Origination Form
Proposed Revisions to a Standard Plans Index

Originator:	Turley, Joshua	Index Number:	400-091
Date:	5/15/2025	Sheet Number(s):	Sheet 2
E-mail:	Joshua.Turley@dot.state.fl.us	Index Title:	APPROACH SLABS (30 FT.) (RIGID PAVEMENT APPROACHES)

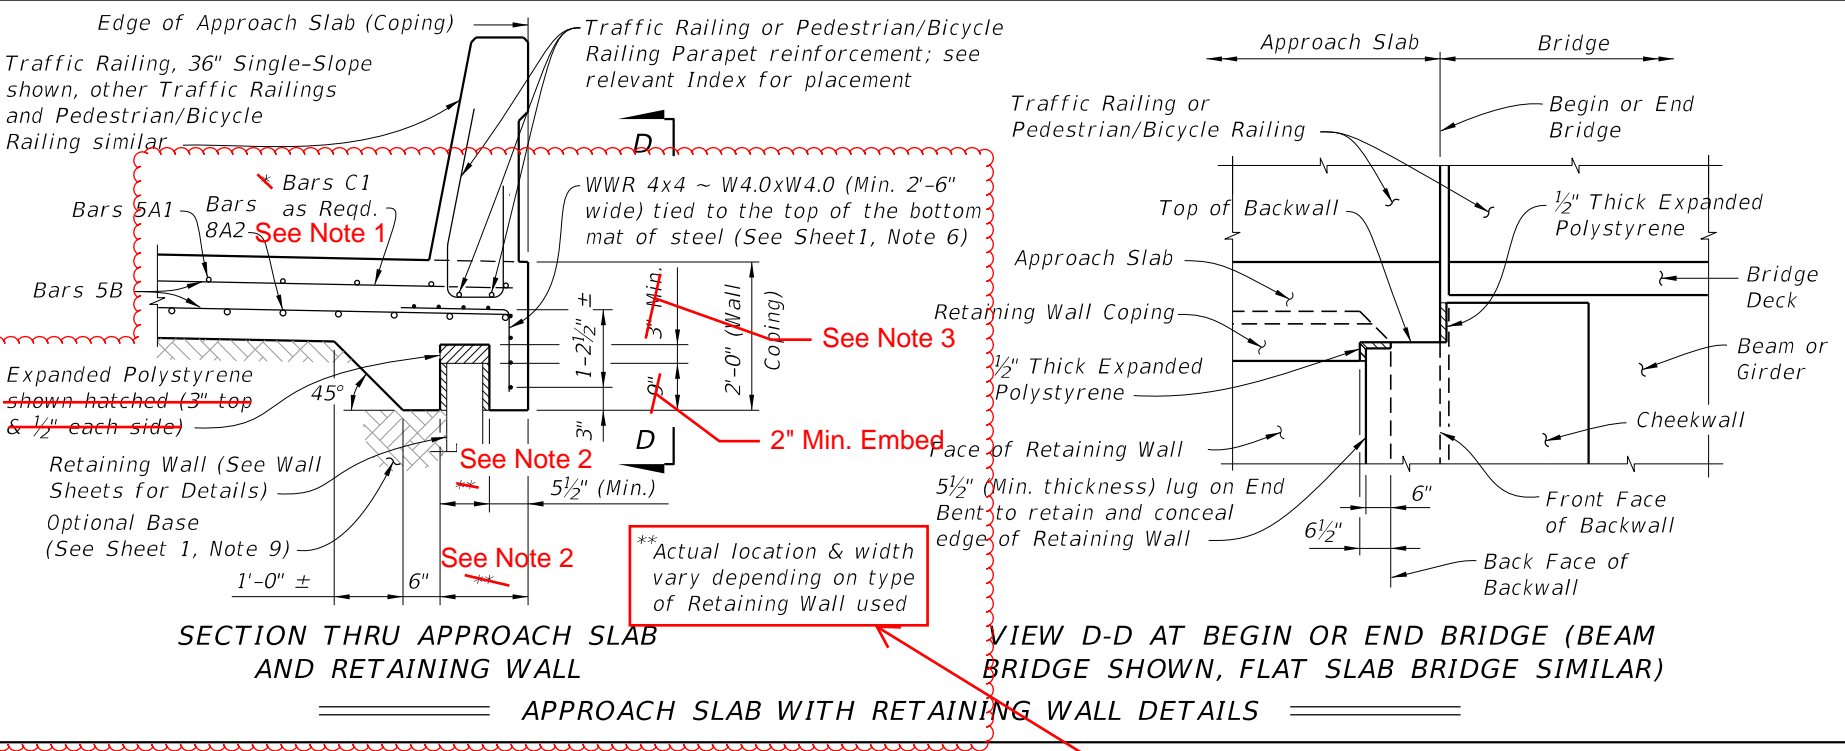
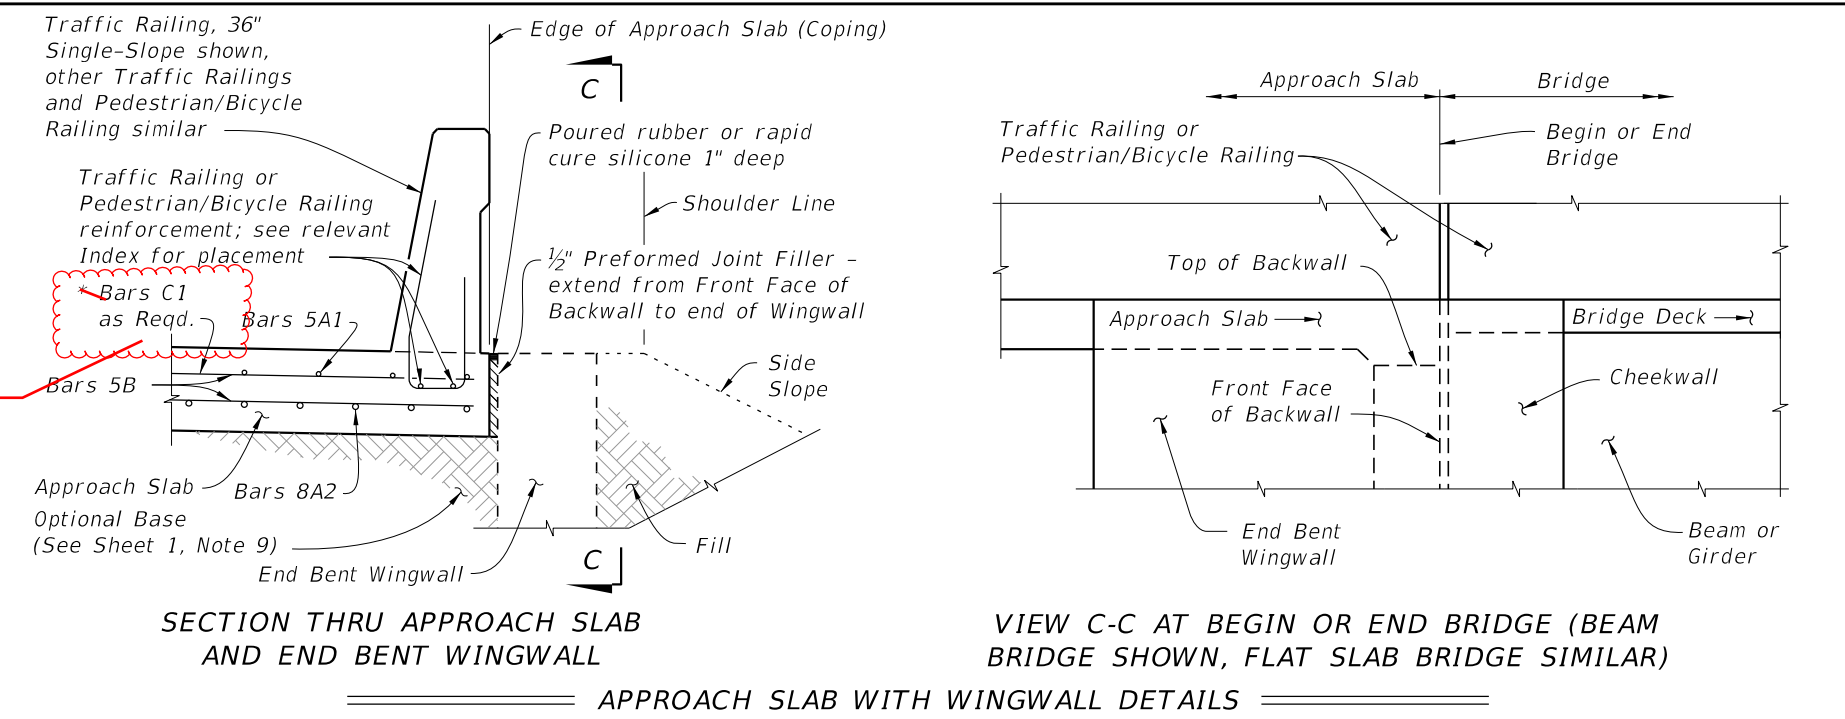
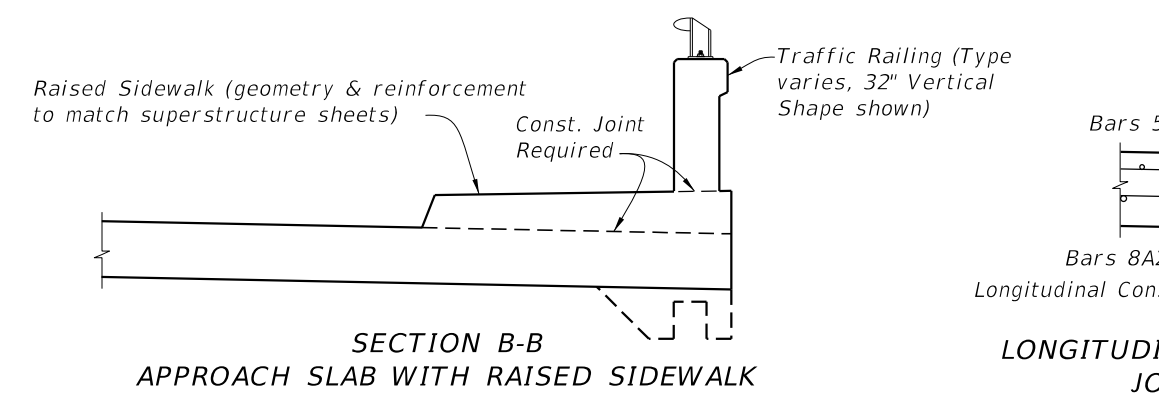
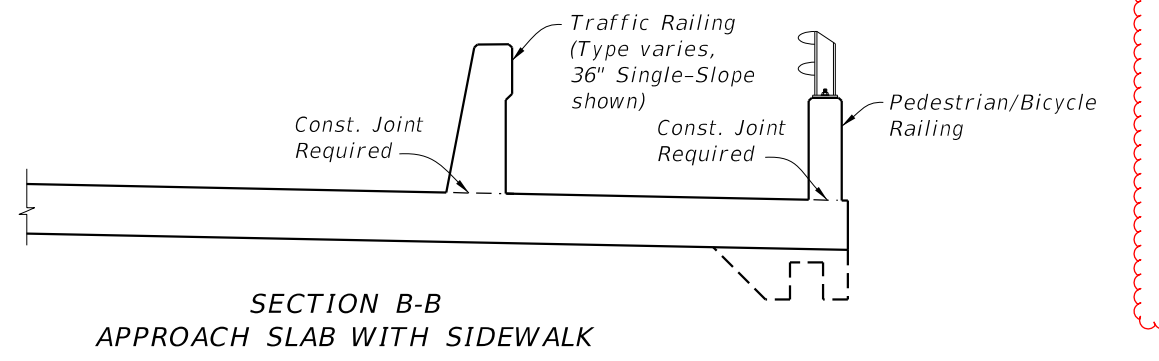
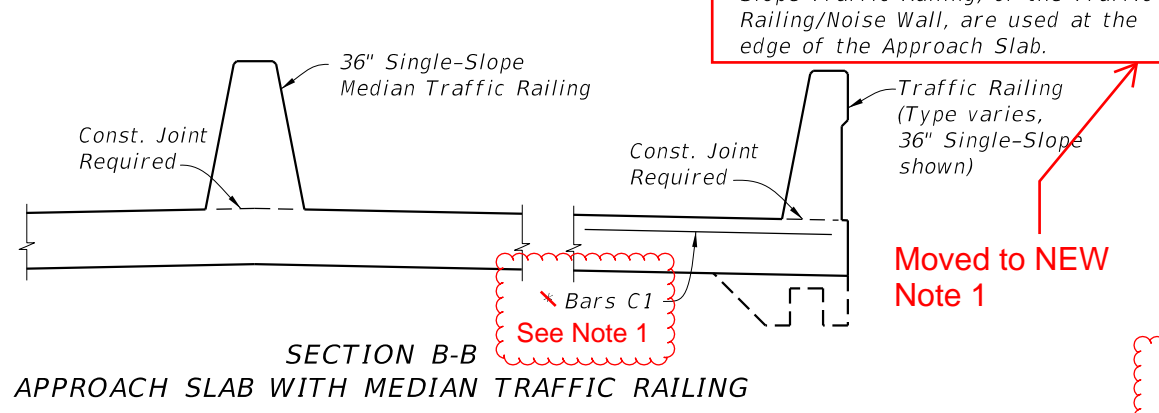
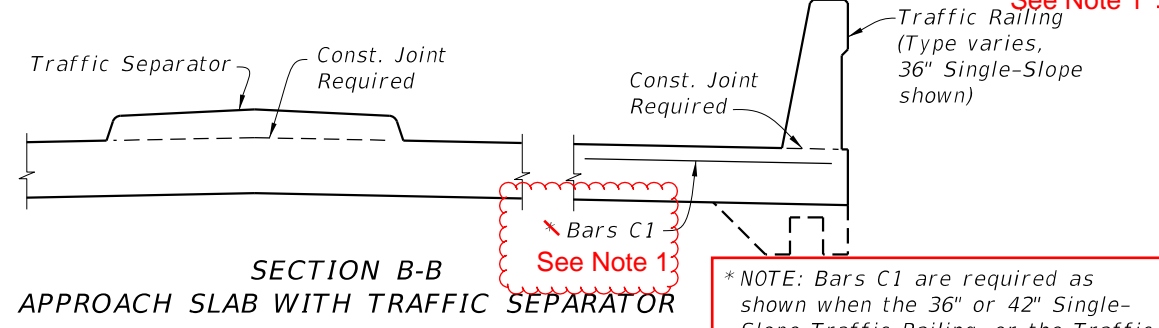
Sheet 2: Converted starred notes to numerical notes. Adjusted the coping embed requirements for the top of the retaining wall in SECTION THRU APPROACH SLAB AND RETAINING WALL.

NEW Notes Section
Notes:
1.
2.
3. Expanded Polystyrene 1" min. top for MSE walls, 3" min. top for rigid retaining walls. 1/2" each side.

**SECTION THRU APPROACH SLAB
AND RETAINING WALL**

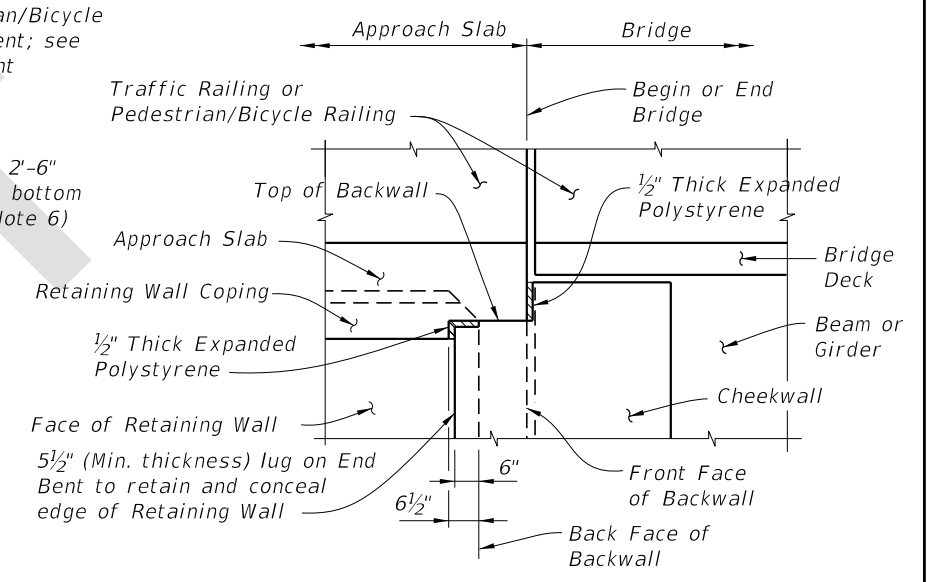
Contractors had trouble meeting top-of-wall elevations for MSE walls due to settlement issues. When predicted settlement didn't occur, walls were too high and required sawcutting. To address this, minimum thickness and embedment requirements for Expanded Polystyrene were relaxed, allowing better control over final wall elevations.

1. Bars C1 are required as shown when the 36" or 42" Single-Slope Traffic Railing, or the Traffic Railing/Noise Wall, are used at the edge of the Approach Slab.
2. Actual location & width vary depending on type of Retaining Wall used.
3. Expanded Polystyrene 1" min. top for MSE walls, 3" min. top for rigid retaining walls. 1/2" each side.
